Sedan Range

**TECHNICAL BULLETIN**

## Front Wheel Arch Liner – Noise During Tight Turns – Repair Procedure

MODEL 1995 MY  
XJR Sedan

ILLUSTRATION 1

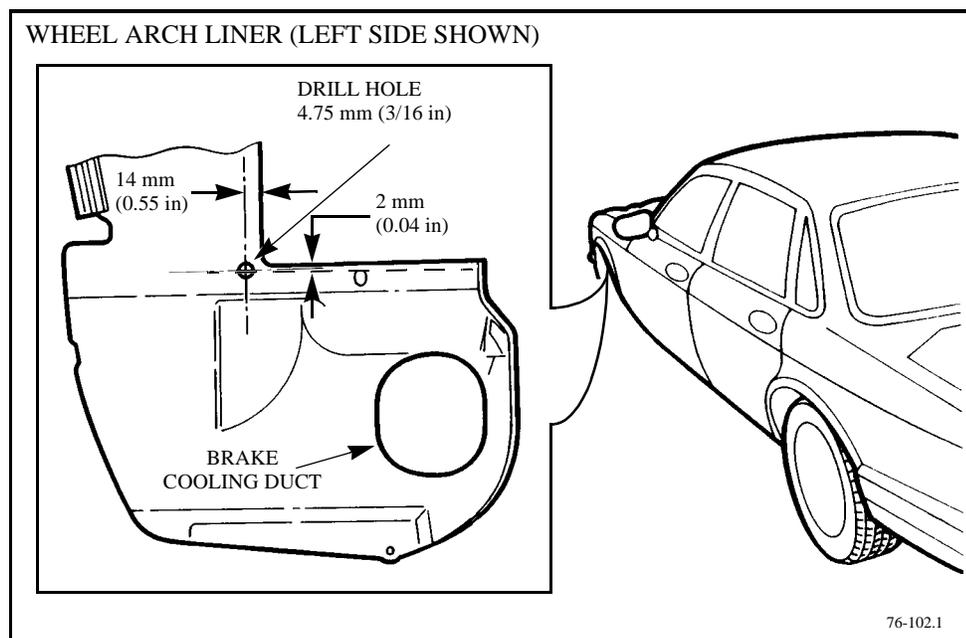
Noise from the front wheel arch area during tight turns. The front tires of 1995 MY XJR Sedans from VIN 720001 - 723157 may contact the wheel arch liner during full lock turns.

If a customer complains of noise during tight turns from the wheel arch area on a 1995 MY XJR Sedan within the listed VIN range, add an additional wheel arch fastener following the procedure described below.

1. Remove both front wheels.
2. Mark two lines parallel with the inside edges of the wheel arch liner using the dimensions shown in Illustration 1.
3. Drill a 4.75mm (3/16 inch) diameter hole through the liner and the body panel at the point where the two lines cross.
